**Title:** Clarification of synchronisation procedure

**25.214 CR 052**

Synchronisation procedure

**Figure 1: Synchronisation establishment flow for dedicated channels: uplink dedicated channel not existing**

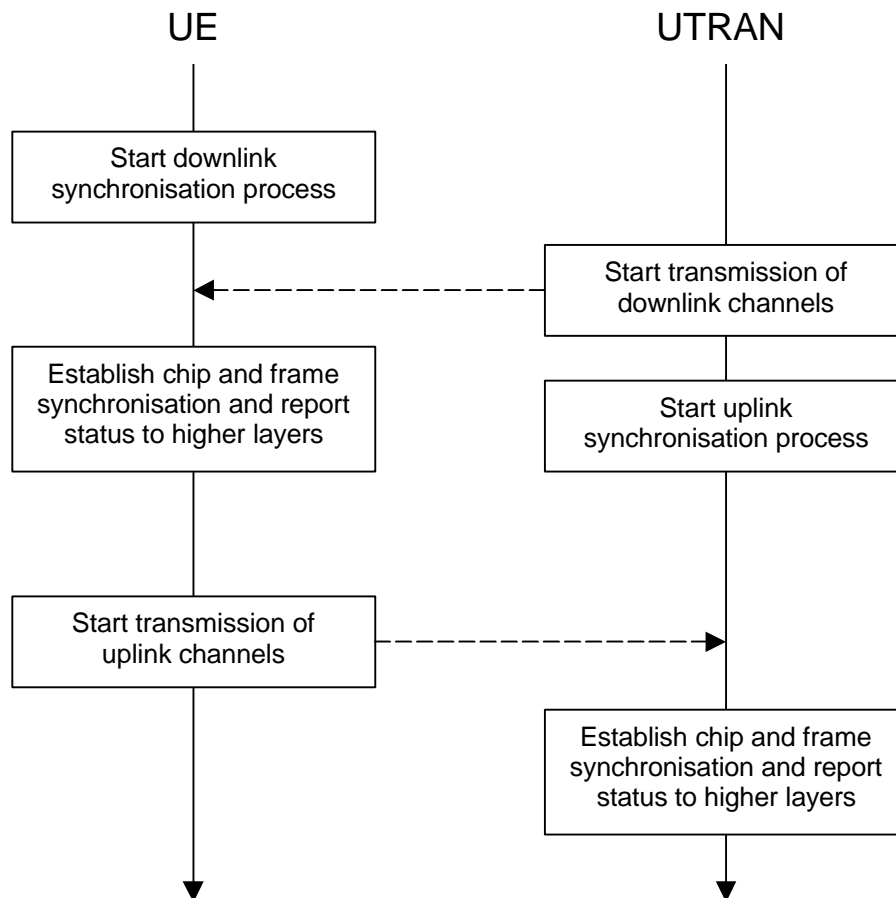
- a) UTRAN starts the transmission of downlink DPCCH/DPDCHs. The DPDCH is transmitted only when there is data to be transmitted to the UE.
- b) The UE establishes downlink chip synchronization and frame synchronization based on the CPICH timing and timing offset information notified from UTRAN. Frame synchronization can be confirmed using the Frame Synchronization Word. Successful frame synchronization ~~is shall be~~ confirmed and reported to the higher layers when-if the first  $S_{RU}$  successive frames have been are confirmed to be frame synchronized, where  $S_{RU}$  is a higher-layer parameter and  $S_{RU} \leq N_{offset,2}$  (see subclause 7.7 in [1]). Frame synchronisation shall also be reported to higher layers in any case if  $S_{RU} = 0$ . Otherwise, frame synchronization failure ~~is shall be~~ reported to the higher layers.

- d) UTRAN establishes uplink channel chip synchronization and frame synchronization. Frame synchronization can be confirmed using the Frame Synchronization Word. Successful frame synchronization ~~is shall be~~ confirmed and reported to the higher layers when-if the first  $S_{RN}$  successive frames have been are confirmed to be frame

synchronized, where  $S_{RN}$  is a higher-layer parameter. Frame synchronisation shall also be reported to higher layers in any case if  $S_{RN} = 0$ . Otherwise, frame synchronization failure ~~is shall be~~ reported to the higher layers.

**Figure 2: Synchronisation establishment flow for dedicated channels: uplink dedicated channel already existing**

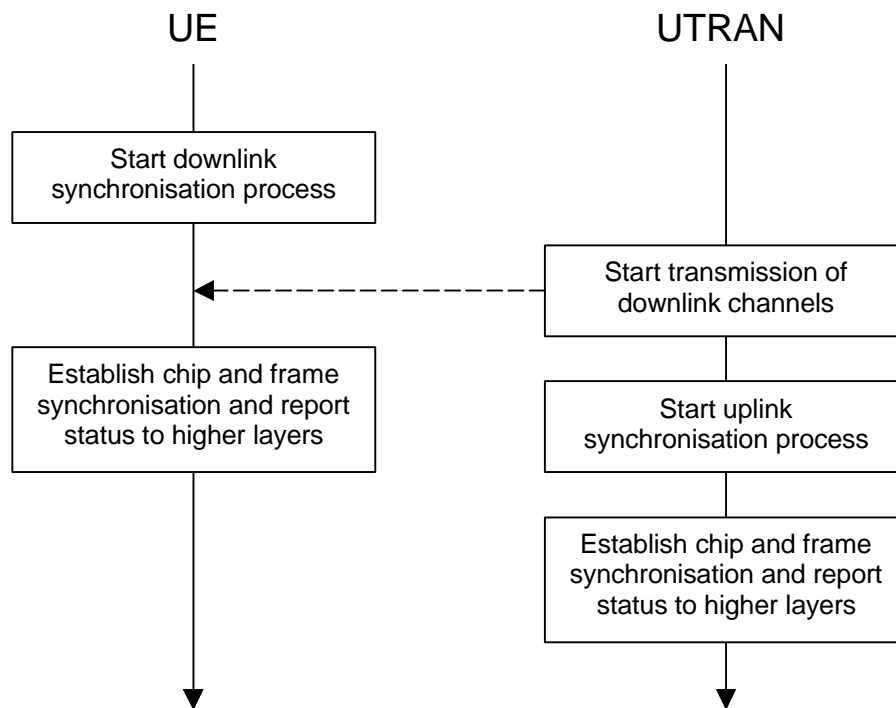
- UTRAN starts the transmission of the downlink DPCCH/DPDCH at a frame timing such that the frame timing received at the UE will be within  $T_0 \pm 148$  chips prior to the frame timing of the uplink DPCCH/DPDCH at the UE. UTRAN then starts the synchronization establishment process of the uplink DPCCH/DPDCH transmitted by the UE. Frame synchronization can be confirmed using the Frame Synchronization Word. Successful frame synchronization ~~is shall be~~ confirmed and reported to the higher layers ~~when-if the first~~  $S_{RN}$  successive frames ~~have been are~~ confirmed to be frame synchronized, where  $S_{RN}$  is a higher-layer parameter. Frame synchronisation shall also be reported to higher layers in any case if  $S_{RN} = 0$ . Otherwise, frame synchronization failure ~~is shall be~~ reported to the higher layers.

- Based on the handover destination CPICH reception timing, the UE establishes chip synchronisation of downlink channels from handover destination cell. Frame synchronization can be confirmed using the Frame

Synchronization Word. Successful frame synchronization ~~is shall be~~ confirmed and reported to the higher layers ~~when if the first~~  $S_{RU}$  successive frames ~~have been are~~ confirmed to be frame synchronized, ~~where~~  $S_{RU}$  is a higher-layer parameter and  $S_{RU}$  (see subclause 7.7 in [1]). ~~Frame synchronisation shall also be reported to higher layers in any case if~~  $S_{RU} = 0$ . Otherwise, frame synchronization failure ~~is shall be~~ reported to the higher layers.
